NACELLE - AIR - CLIPS, OVERHEAT DETECTOR - REPLACEMENT OF - CATEGORY CODE 5 -
MOD.NAC-75-0056

V2500-NAC-75-0056

SERVICE BULLETIN

REPLACEMENT OF CLAMPS ON CORE OVERHEAT DETECTOR.
Fig.1

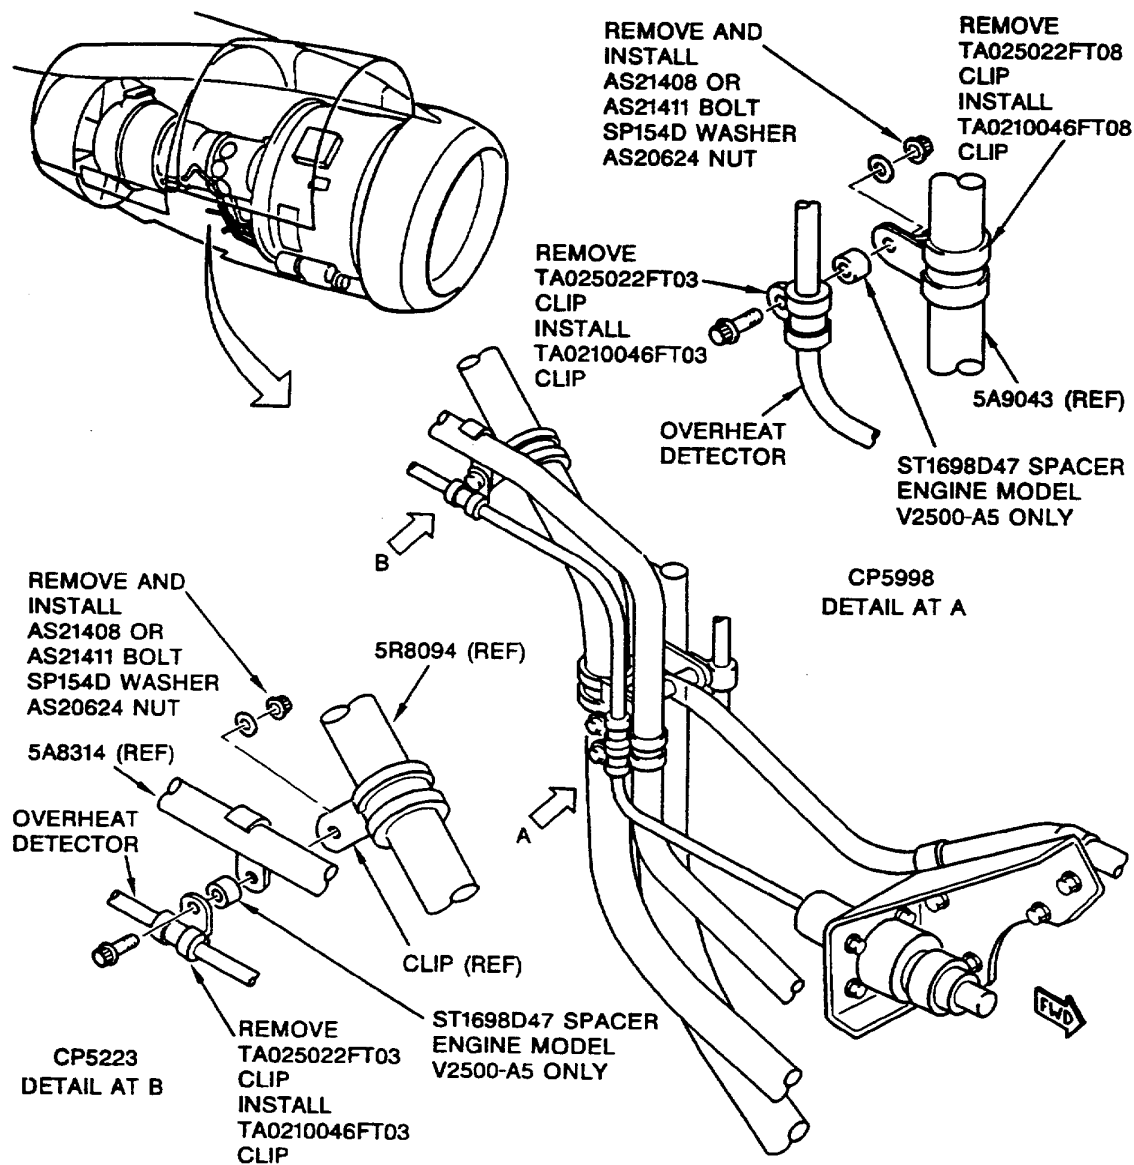
- (1) Condition
- Operators have reported frettage to overheat detector at clipping points.
- (2) Background
- Clip inserts have shown wear and/or are missing from clips.

- (a) The clip that supports the overheat detector at clipping point CP5223 is replaced. Both clips at clipping point CP5998 are also replaced. Refer to Figure 1.

- (1) Remove the TA025022FT03 P-clip from clipping point CP5223. See Figure 1.
- (2) Assemble clipping point CP5223 as shown, with new TA0210046FT03 P-clip, AS21408 bolt, SP154D washer, and AS20624 nut.
- (3) Remove the TA025022FT03 P-clip and TA025022FT08 P-clip from clipping point CP5998.
- (4) Assemble clipping point CP5998 as shown, with new TA0210046FT03 and TA0210046FT08 P-clips, AS21408 bolt, SP154D washer, and AS20624 nut.
- (5) Torque the nuts in steps (2) and (4) to 40 lbf-in (4.6 Nm).
